Reference: Engineering Services

865 Coachman Way Sanford, NC 27332

TE&D Project No.: 2401-020288

1) We understand the existing rear deck is to be removed and replaced with a new 3-Season Room. We are providing an analysis of the framing for the proposed space.

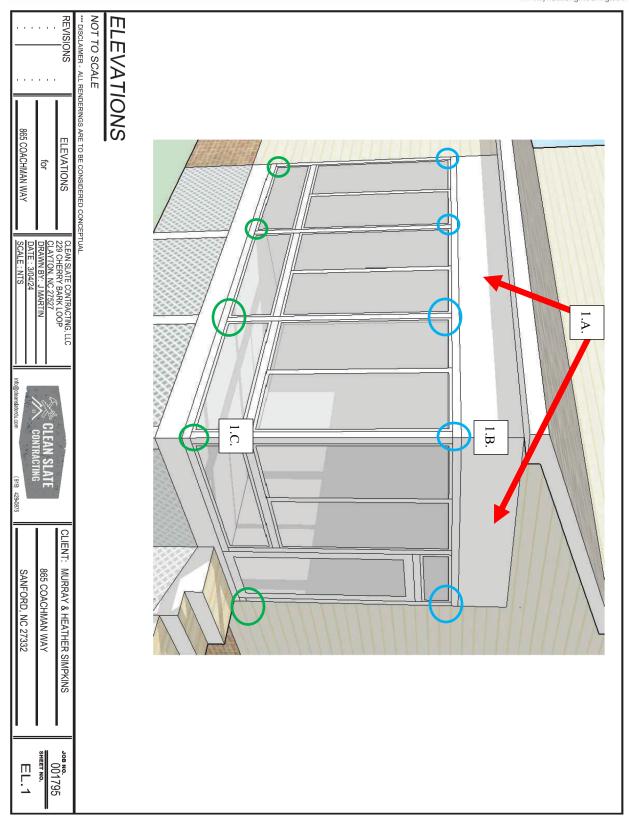
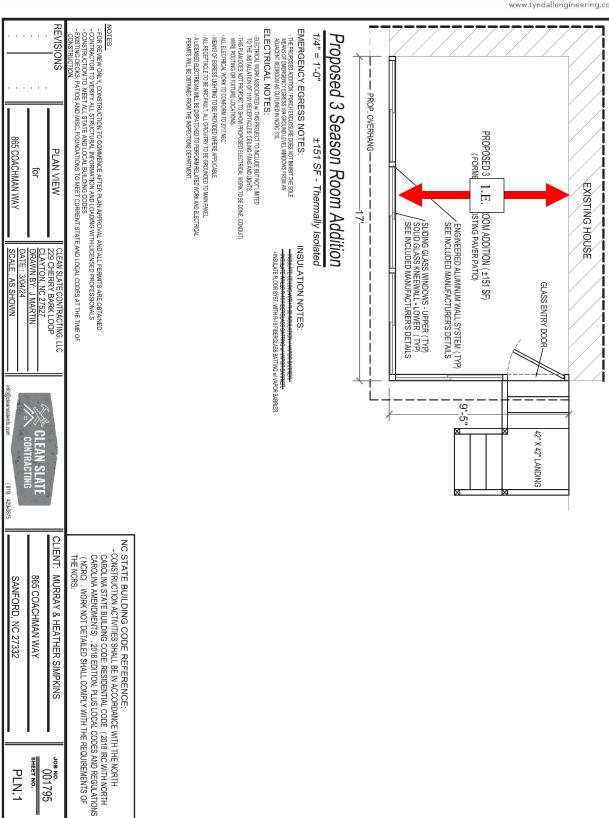
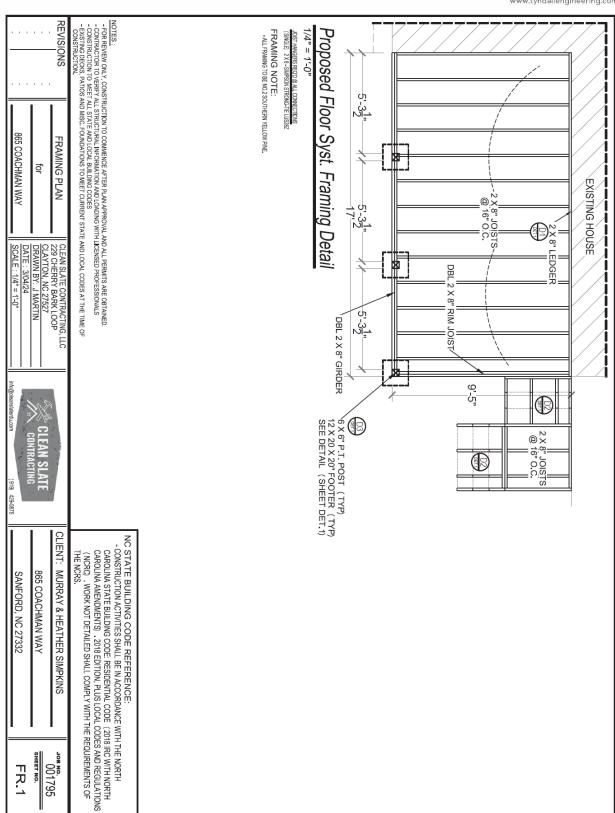
We understand the existing deck framing and foundation is to be removed and replaced per the plan provided by the client and included with this report. Based on our understanding and analysis, the proposed deck framing and foundation is adequate to support the anticipated loading conditions.

We understand the walls and roof of the sunroom are to be framed per the plans provided by the client and included with this report. Based on our observations and analysis, we recommend the following:

- A) The proposed wall headers are to consist of minimum (2) 2 x 12 headers.
- B) The aluminum posts are to be connected to each of the top brackets with a total of (4) 1/2" TEC screws (1 screw from each side of the post). The brackets are to be attached to the top beams with (4) 6" long Fastenmaster Timberlok screws.
- C) The aluminum posts are to be connected to each of the bottom brackets with a total of (4) 1/2" TEC screws (1 screw from each side of the post). The brackets at the bottom of the posts are to be fastened to the beam below with (2) 6" long Fastenmaster Timberlok screws per side.
- D) The aluminum tracks securing the posts to the beams above and below are to be installed with 6" long Fastenmaster Timberlok screws installed at 24" o.c. and within 12" of corners.

E) New rafters and ceiling joists are to consist of minimum 2 x 8 at 16" o.c. rafters/joists. Rafters/joists are to bear on the existing home with new 2 x 8 bands attached to the existing wall framing with (3) 2" SDS screws at 16" o.c. (i.e. every stud).
